SERVICE LETTER

No. 619

Subject: Inspection of Piper part number 83302-13 Retainer Spring

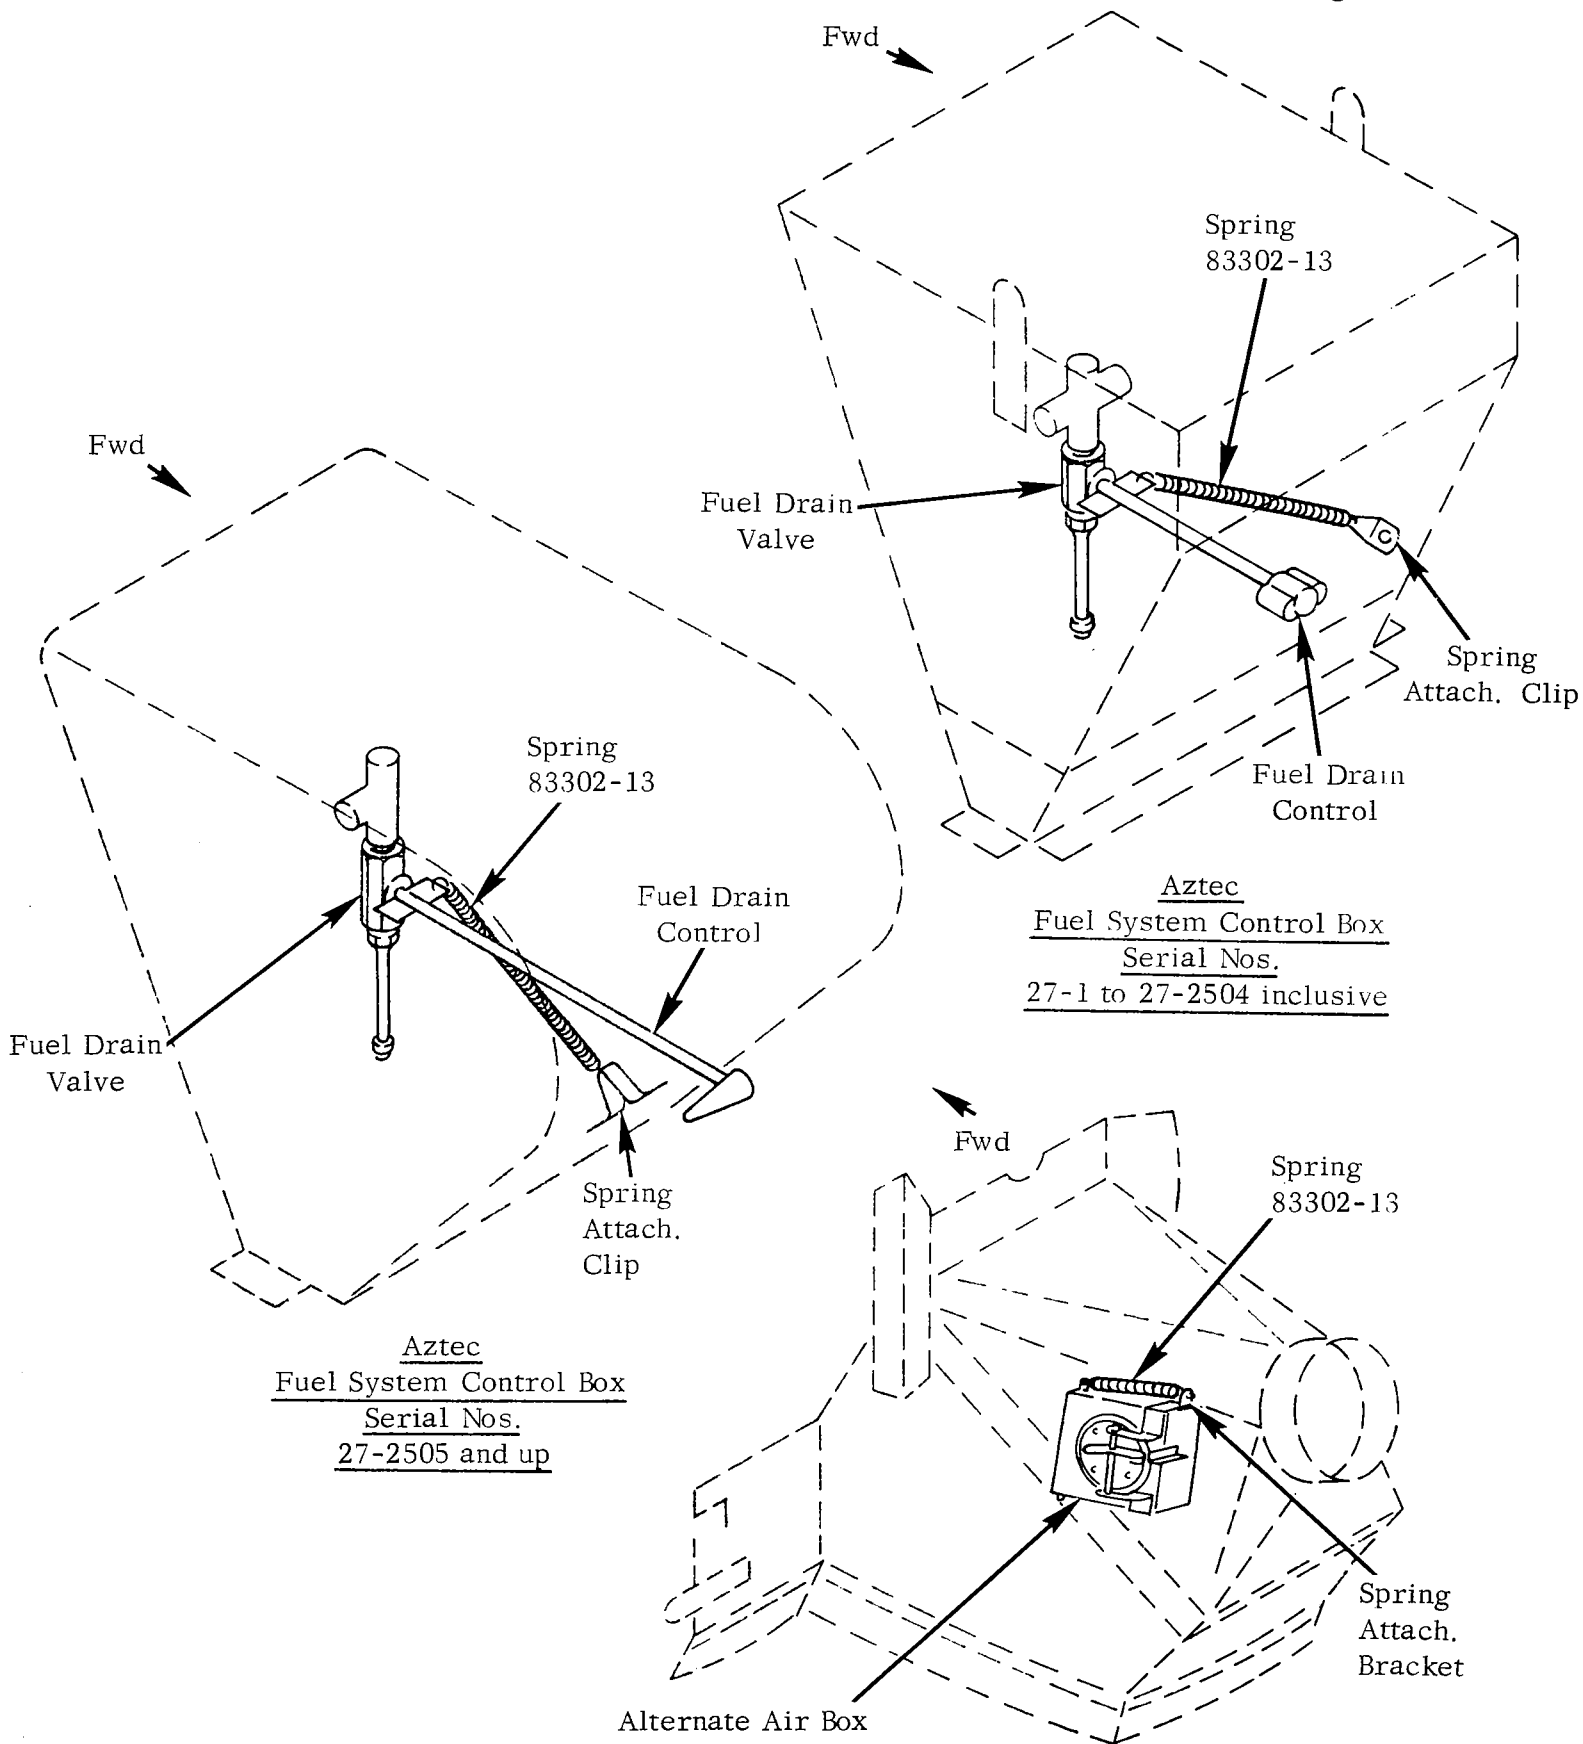
Refer to attached sketch for an illustration of these areas.

1. Gain access to the Aztec Fuel Control Box and Navajo Air Filter Plenum Assembly; refer to attached sketch for a general illustration.
2. Remove the spring from the Aztec Fuel Drain Control Stem and Navajo Alternate Air Box Door Assembly and install replacement spring (see Material Required, below).
3. Make appropriate log book entry.

1. Aztec Fuel Control Box: One (1) each (per aircraft) Retainer Spring, part number 83302-13.
2. Navajo Alternate Air Box Door: One (1) each (per Alternate Air Box) Retainer Spring, part number 83302-13.
